**CONWAY
HISTORIC DISTRICT COMMISSION
MEETING**

DECEMBER 21, 2015 • 6:00PM • CITY HALL • 1201 OAK STREET

1A MCANEAR RESIDENCE REMODEL - 320 MITCHELL STREET

OLD CONWAY DESIGN OVERLAY DISTRICT CERTIFICATE OF APPROPRIATENESS REVIEW

Proposed design options

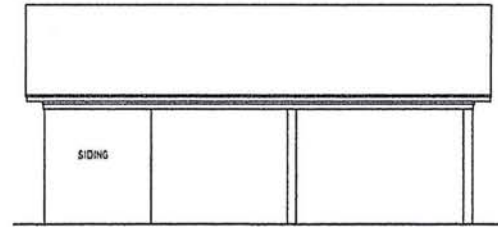
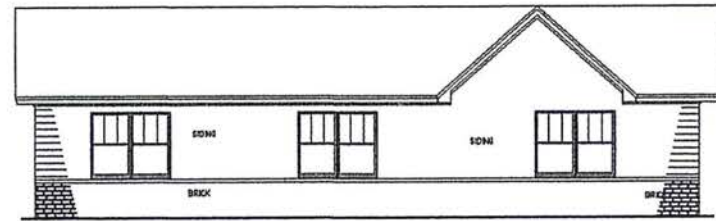
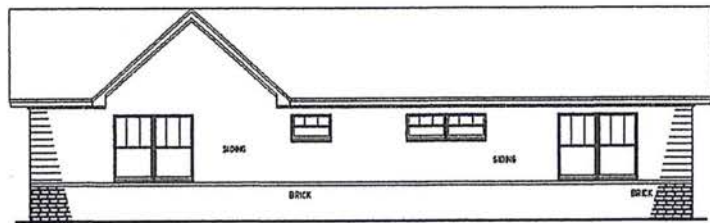
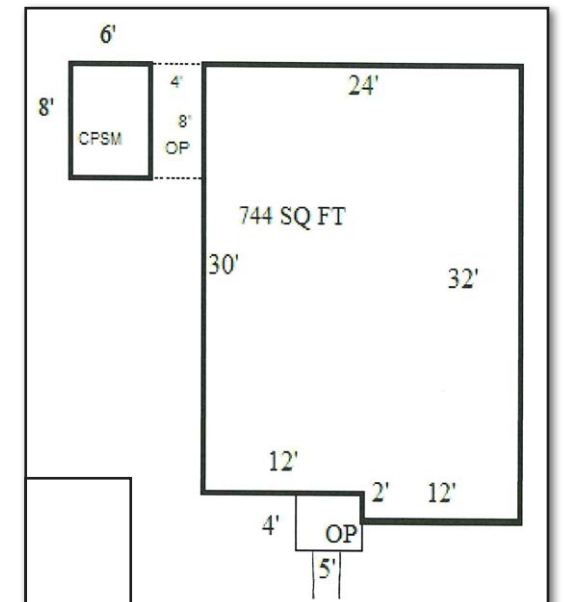
Complexity of form. The level of detailing and breaks in wall planes of a structure. The residence has minimal detailing accomplished with wide window and door trim. The residence's wall planes are broken by a gabled front façade with a small gabled portico. There are also gables on the sides. The proposed rear addition would not affect the complexity of form. The applicant has proposed two possible front façades. Elevation A would change the current front to a new, more flat appearance by creating a new wide gable. Elevation B also pushes the double window wall forward, but adds a low angled roof to cover the porch area.

Entries, Porches, and Porticos. Appropriate entry points are provided. Porches are to be a minimum of 6 feet in depth. The front porch shown is small, but 6 feet in depth. Columns width should have a solid appearance.

Doors and windows. The front door is shown as a solid panel door. Rear doors are shown as full glass patio doors and a 1/2 light door. Windows are shown with 3 lights over one in a craftsman style. The original craftsman style windows seem to be intact. These should remain if possible. Smaller matching privacy windows are shown on the right elevation for bathrooms.

Architectural Details, Siding, and Bricks. Eaves, brackets, dentils, cornices, molding, columns, trim, etc. The existing residence has minimal details accomplished through wide door and window trim and decorative "pork chop" eave returns. These details should be retained. The original wood siding appears to be in place. The applicant would like to add a brick band around the lower bout of the house and replace the wooden siding with a vinyl or similar wood shake siding above. The applicant has included a photo of 1833 Johnston with a similar façade treatment.

1. The residence shall be constructed as shown in submitted plans. Or modified as prescribed by the HDC.
2. Driveway shall be concrete.
3. The residence's front setback shall be approximately 16 feet from the front property line. Outbuilding setbacks shall be approximately five (5) feet from the south property line and fifteen (*15) feet from the east property line.

4. Original windows should be preserved and reused as much as possible. External or internal storm windows are allowed.
5. Porch columns shall be a trimmed out to approximately eight (8) inches by eight (8) inches.

6. The two significant trees as shown shall be preserved.
7. Siding materials as used at 1833 Johnston shall be used.
8. HVAC and utility equipment shall be appropriately located at the rear or side of the structure and/or appropriately screened.

Proposed Design

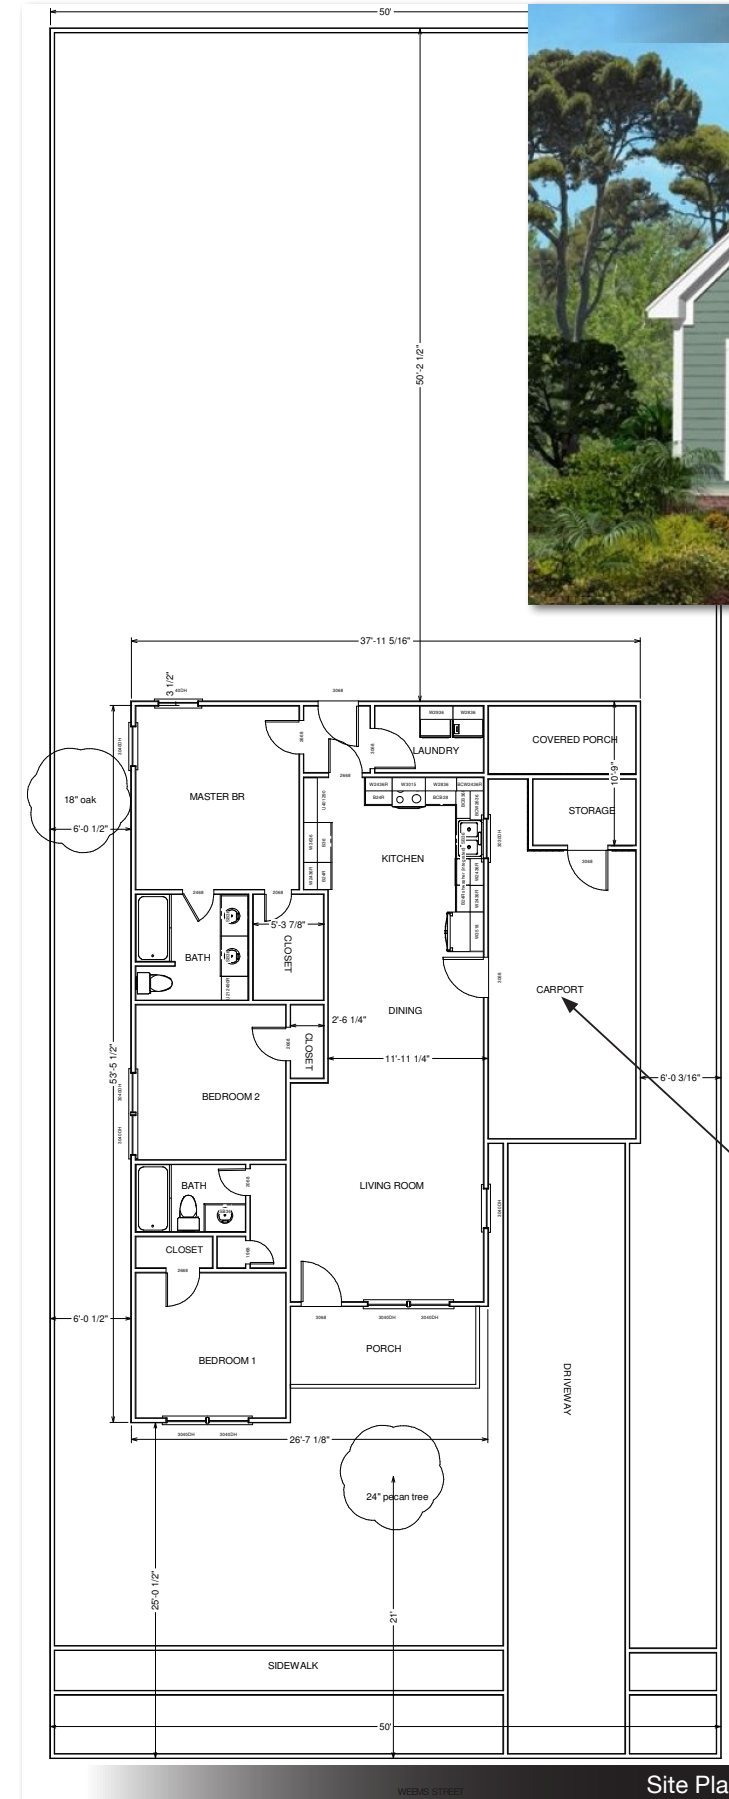
Complexity of form. The level of detailing and breaks in wall planes of a structure. The residence has appropriate detailing accomplished with wide window and door trim. The residence's wall planes are broken by a gabled front façade and a small porch. Gables are also used on the sides. The floor plan shows a carport with rear storage areas. The perspective view does not show the carport. A staff created sketch shows the roof line and carport side elevation.

Entries, Porches, and Porticos. Appropriate entry points are provided. Porches are to be a minimum of 6 feet in depth. The front porch shown is small, but 6 feet in depth. Porch column width has a solid appearance. The column width should also be used on carport columns.

Doors and windows. The doors and windows shown have muntin dividers creating two over two windows. Simple one over one windows would be more appropriate than windows with false dividers.

Architectural Details, Siding, and Bricks. Eaves, brackets, dentils, cornices, molding, columns, trim, etc. The residence has detailing provided through wide door and window trim and open rafter tails over the front porch. These features add traditional detailing. The applicant has not provided the type of siding material. Fiber cement siding is preferred.

1. The residence shall be constructed as shown in submitted plans.
2. Driveway shall be concrete.
3. The residence's front setback shall be approximately 25 feet from the back of curb.
4. Porch columns including carport columns shall be a trimmed out to approximately 8 inches by 8 inches.
5. Floor to ceiling height shall be 9 foot minimum.
6. The two significant trees as shown shall be preserved.
7. Siding material?
8. A 10 foot concrete driveway shall be constructed as shown. A "ribbon" drive may also be used.
9. HVAC and utility equipment shall be appropriately located at the rear or side of the structure and/or appropriately screened.
10. A 4 foot sidewalk shall be constructed along Weems Street.

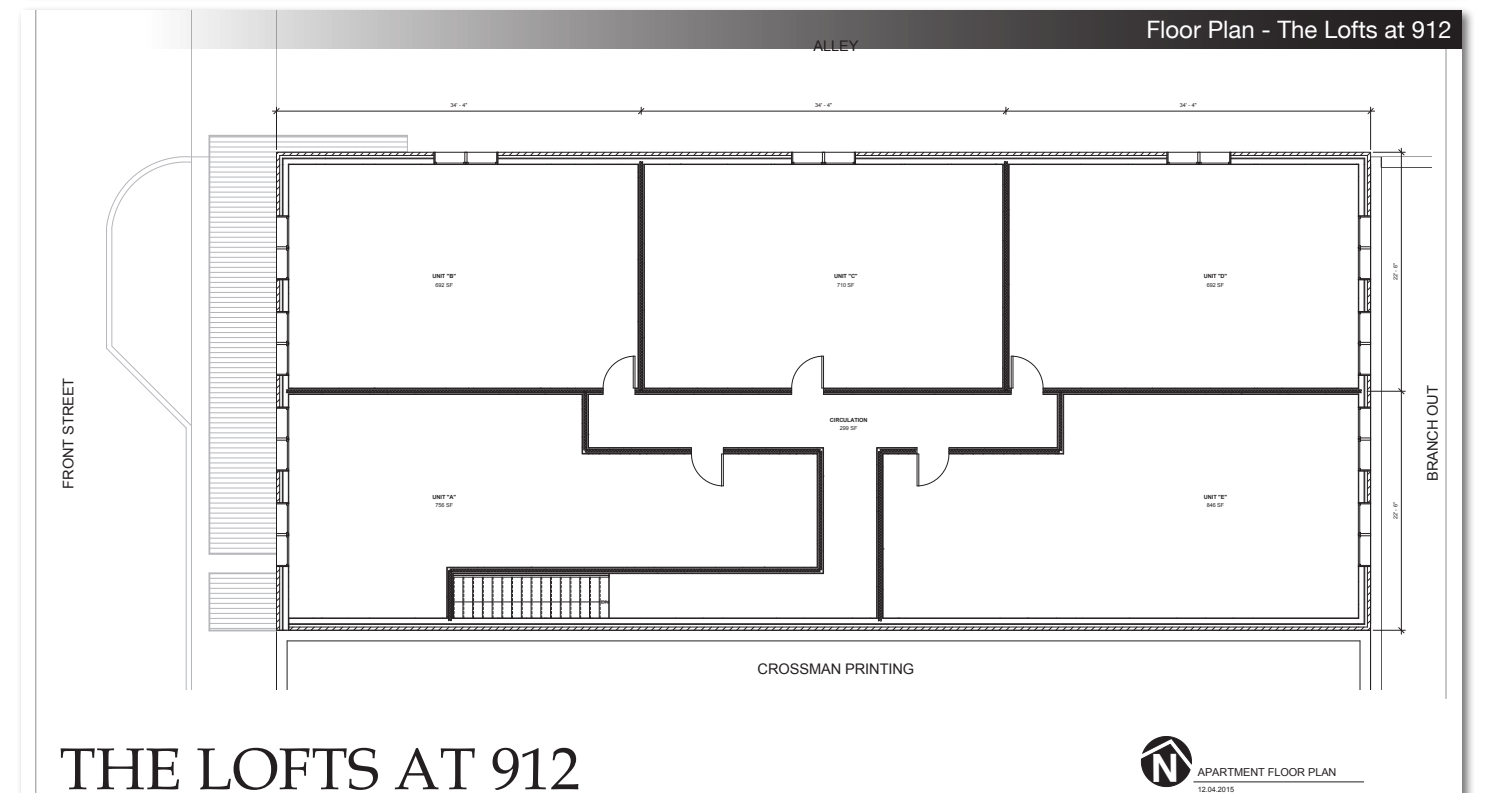
three-dimensional surface modulations. Building façade designs shall respect the historical context of Old Conway with a clear ground floor, body, and cornice line (i.e. “base, body, and cap”). Designs should be contextual to adjacent buildings, including their cornice lines and horizontal banding. The use of traditional façade components is encouraged and includes parapets caps, cornices, transoms, awnings, storefronts, kickplates, recessed entries, and sign bands. The proposed façade will replicate the existing historic façade. The new façade is appropriate.

Building materials (other than glass) shall include brick, stone, concrete, architectural metals, stucco/plaster, and wood trim. Historically, these are among the most widely-used, identifiable, and longest-lasting materials within Conway’s Urban Zone, and therefore the most desirable for all projects. All materials shall be highly durable, attractive, and easily maintained, especially at street level where pedestrians come in contact with the building. Prohibited materials shall include wood siding, pressed wood siding, composite siding, vinyl siding, and all forms of sheet metal sheathing. Exterior insulated finishing systems (EIFS) are discouraged. (EIFS) shall only be applied in upper story areas or other areas not susceptible to impact damage. These materials are not contextual to Old Conway and are generally perceived to be less permanent in nature, therefore they are not appropriate for use within the Urban Zone. The structure will have a brick front façade. The alley side of the structure is shown with a stucco material. Confirmation of alley side material is needed.

be designed as separate entries and distinguished from ground-level uses with architectural details, materials, colors, lighting, signage, and/or paving, so that it is clear which entries are public and which are private. The structure plans show appropriate recessed entries for the restaurant and lofts on the Front Street façade.

1. The structure shall be constructed as shown in submitted plans.
2. Alley way façade wall material shall be...
3. Sanitation service area and appropriate screening shall be determined as part of the Planning Department development review.

SOUTH ELEVATION (FACING OAK STREET)

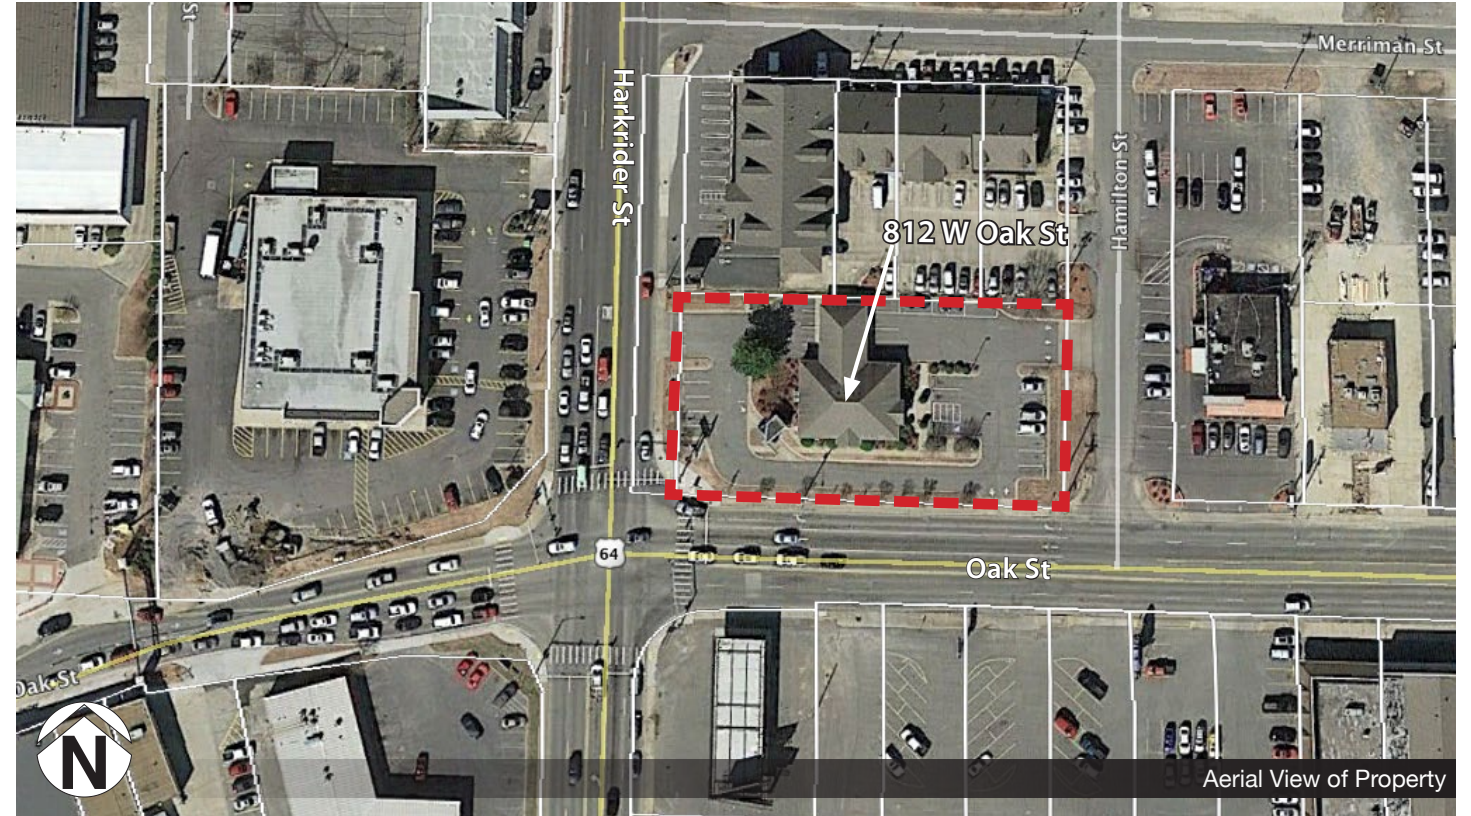
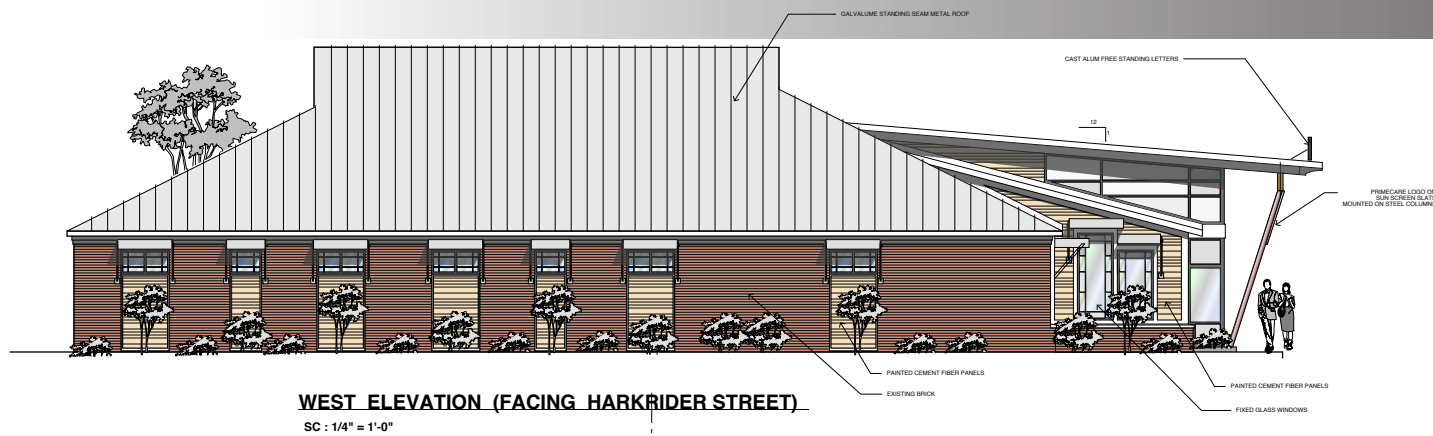
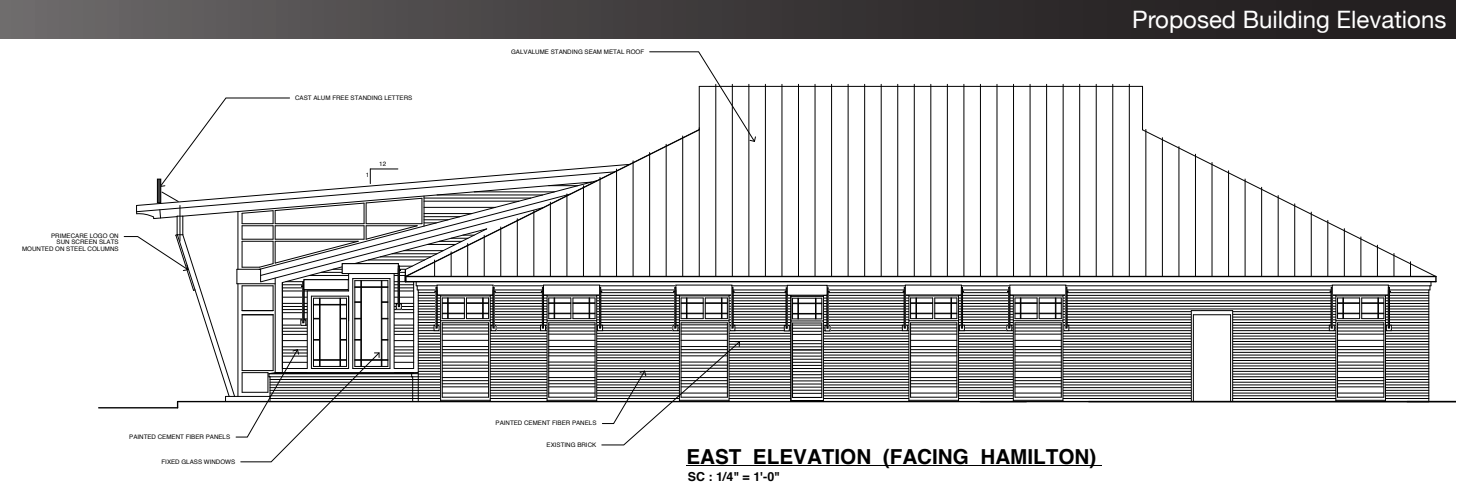
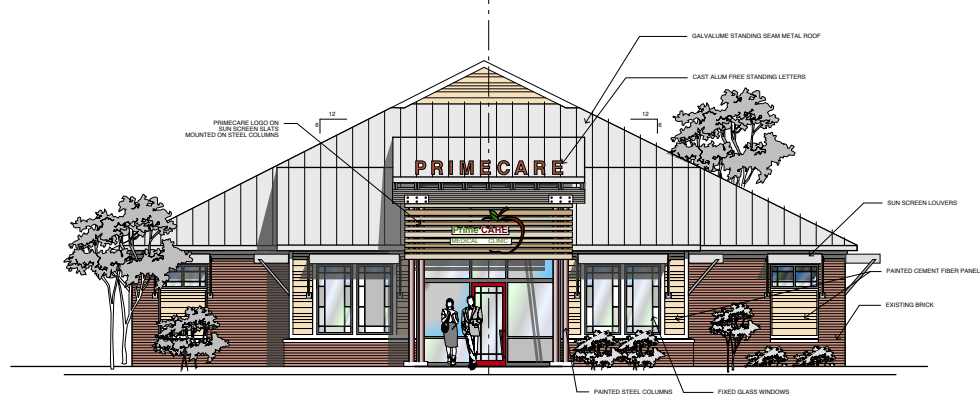
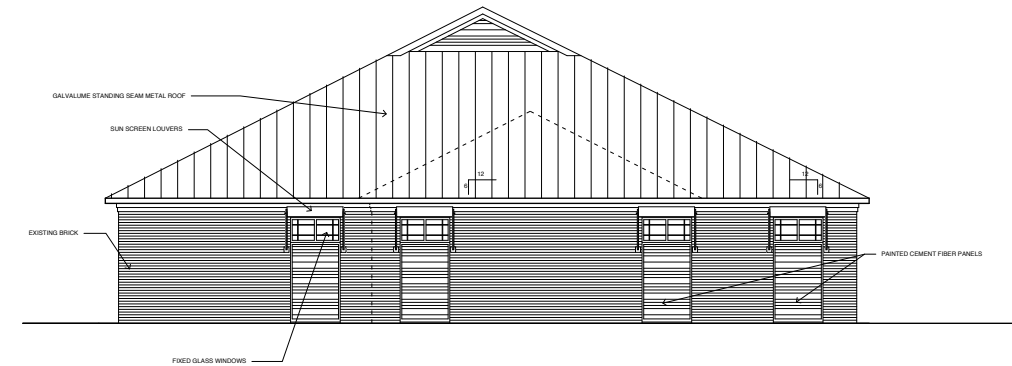
These regulations pertain more to a true urban downtown façade. The proposed addition would add articulation and a more vertical element to the Oak Street façade.

The structure has brick façades. New high windows with fiber cement accent panels are proposed for the examination rooms. The new entry area is mainly glass. A standing seam metal roof is proposed.

The structure plans show an appropriate Oak Street entry. However, to better connect to Oak Street and "announce" the entry, a more vertical treatment is encouraged. A more vertical feature could be easily seen while traveling down Oak Street and match the height of the new CVS. A change in the slope of the entryway roof from down to up would emphasize the entry. However, this creates roof drainage technical challenge. A "tower" feature or other means could also be used.

3. More vertical feature at front entrance is required. Height should match the CVS. Planning staff may approve during Planning development review.
4. Curb cuts on Harkrider and Hamilton shall be reduced to 20 foot widths
